Access Compliance Report

Public Rights-of-Way

(Curb Ramps)

Intersection ID: 42927	Main Street: BRAY_DR	Cross Street: FOYNES_CT	Location: NE
ADA ID: A54E606DA85D	Ramp Type: PerpDiag	Initial Pass/Fail: Fail	Overall Compliance: No
Severity Score: 33.75			
Codes/Mitigation Info/Possible Solution		Field Measurements/Component Compliance

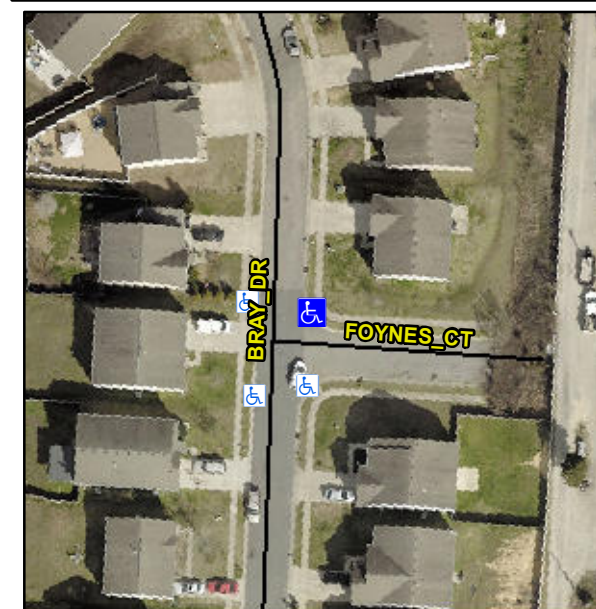
Not Found, R304.5.1, R304.5.3

Compliance	Description	Data	Compliance	Description	Data
N/A	Ramp Length (in)	47.0	Yes	Ramp Slope (%)	6.3
No	Ramp Width (in)	37.0	No	Ramp XSlope (%)	12.6
N/A	Flare Type LT	N/A	N/A	Flare Type RT	N/A
N/A	Flare Slope LT (%)	N/A	N/A	Flare Slope RT (%)	N/A
N/A	Flare Traversable LT?	N/A	N/A	Flare Traversable RT?	N/A
N/A	Landing Length (in)	N/A	N/A	DWS Provided?	N/A
N/A	Landing Width (in)	N/A	N/A	DWS Contrast?	N/A
N/A	Landing Slope (%)	N/A	N/A	DWS Length (in)	N/A
N/A	Landing X Slope (%)	N/A	N/A	DWS Full Width?	N/A
N/A	Landing Curb? (Y/N)	N/A	N/A	DWS Offset (in)	N/A
N/A	Shared Landing?	N/A			
N/A	Gutter Ponding?	N/A	N/A	Gutter Slope (%)	N/A
N/A	Gutter Lip Ht (in)	N/A	N/A	Gutter X Slope (%)	N/A
N/A	Painted X Walk1?	No	N/A	Painted X Walk2?	No
	X Walk 1 Direction	To W		X Walk 2 Direction	To S
N/A	X Walk 1 Width (in)	N/A	N/A	X Walk 2 Width (in)	N/A
	X Walk 1 Slope (%)	1.7		X Walk 2 Slope (%)	3.6
	X Walk 1 X Slope (%)	7.0		X Walk 2 X Slope (%)	4.5

Remove & Replace Curb Ramp With Two New Directional Ramps or Equivalent.
